SUBJECT: ISSUANCE OF AMENDMENT NO. 10 TO FACILITY OPERATING LICENSE
NPF-29 GRAND GULF NUCLEAR STATION, UNIT NO. 1

AMENDMENT TO FACILITY OPERATING LICENSE

Amendment No. 10
License No. NPF-29

SAFETY EVALUATION BY THE OFFICE OF NUCLEAR REACTOR REGULATION
RELATED TO AMENDMENT NO. 10 TO FACILITY OPERATING LICENSE NPF-29

FIGURE 6.2.1-1 OFFSITE ORGANIZATION

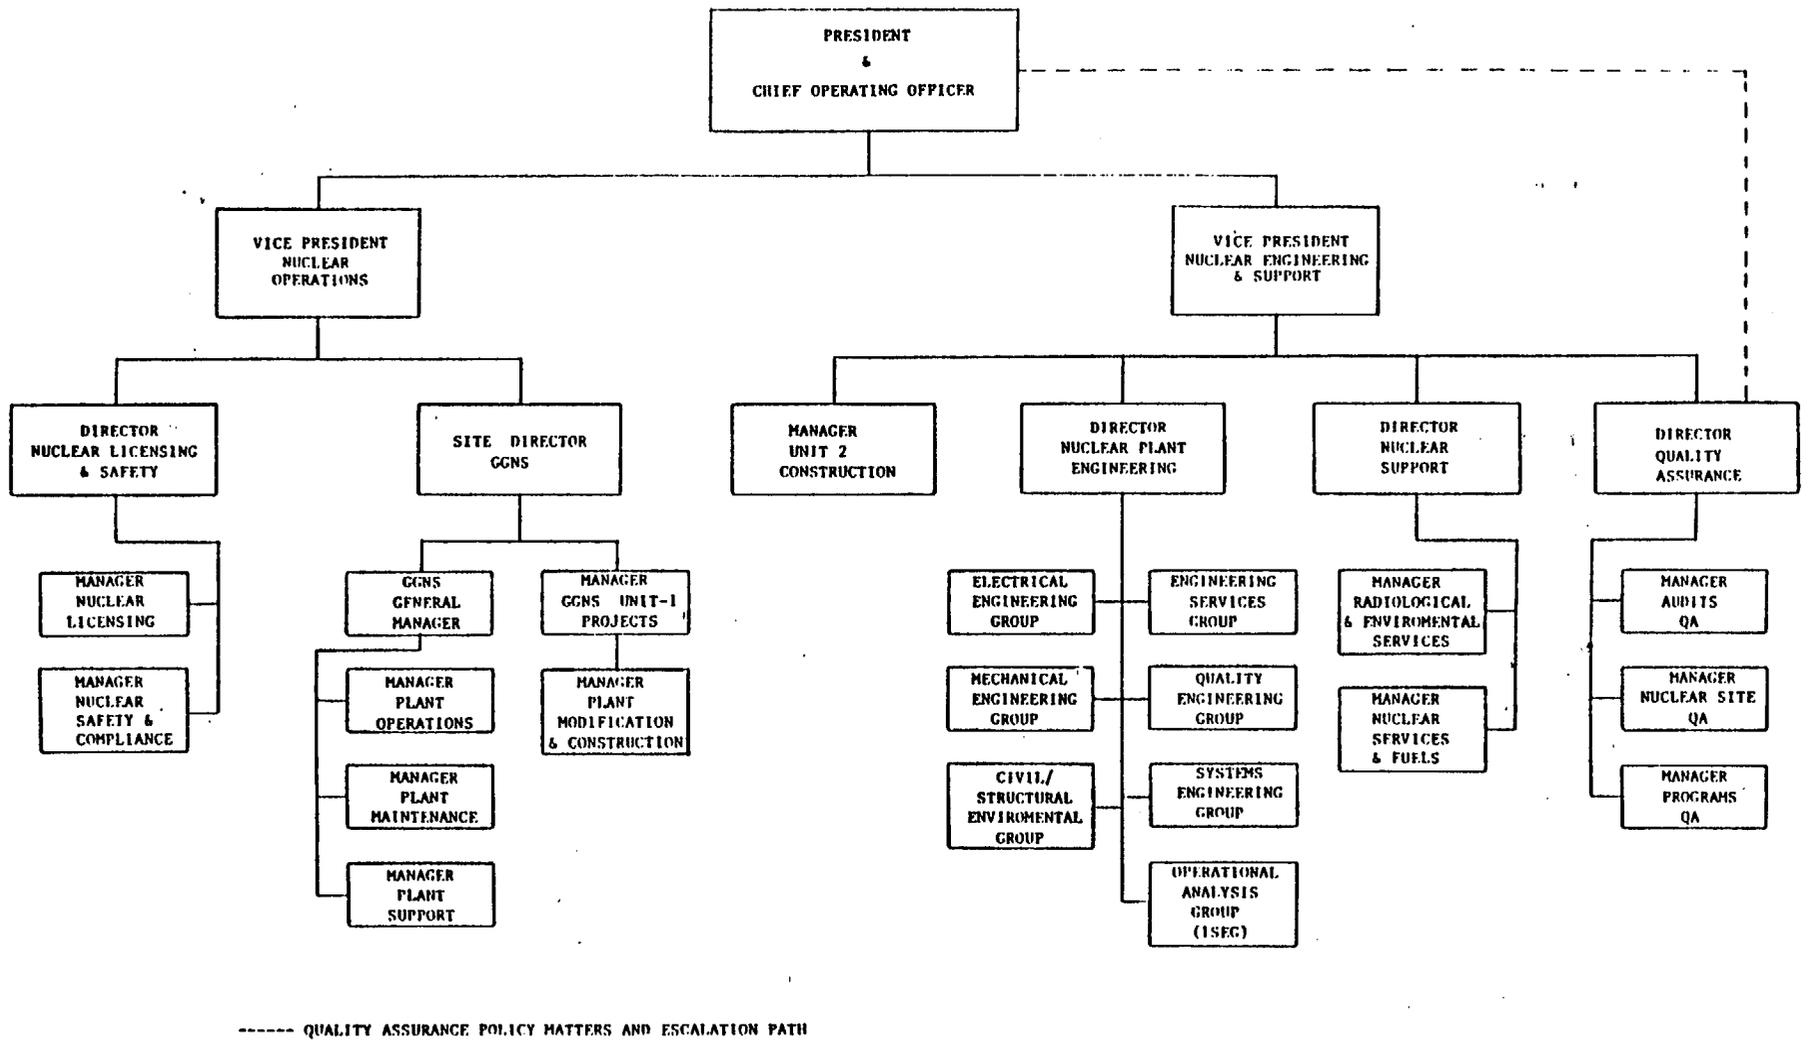
The revised chart (Technical Specification Figure 6.2.1-1) includes the following newly created positions: the President and Chief Operating Officer; the Vice President, Nuclear Engineering and Support; the Site Director, GGNS; the Manager, GGNS Unit 1-Projects; and the Manager, Plant Modification and Construction.

The President and Chief Operating Officer of MP&L has the ultimate responsibility for providing top level direction of all activities associated with the operation of GGNS through the Vice President, Nuclear Operations and the Vice President, Nuclear Engineering and Support. In addition, he will provide guidance on corporate quality assurance policy to the Director, Quality Assurance. The Director, Quality Assurance will maintain his independence by having a direct escalation path to the President and Chief Operating Officer.

The position Senior Vice President, Nuclear will be deleted since the President and Chief Operating Officer will assume the responsibility for providing top level direction of the activities associated with GGNS. All references in Section 6.0 of the Technical Specifications to Senior Vice President, Nuclear have been changed to Vice President, Nuclear Operations.

The new position of Vice President, Nuclear Engineering and Support and the positions reporting to him place more emphasis on the engineering and support functions in support of the operation of GGNS Unit 1 and less emphasis on the construction of GGNS Unit 2.

The new position of Site Director, GGNS will provide a higher level of management involvement at the site for problem solving and interfacing with other organizations.

The staff finds that the above proposed changes in the offsite organization should promote management control and effective lines of authority and communication between organizational units involved in management, operation and technical support. This meets the criteria in Sections 13.1.1 and 13.1.2 of NUREG-0800, the Standard Review Plan (SRP) and is in accordance with the guidance provided in NUREG-0731. Therefore, we find the organizational changes acceptable.
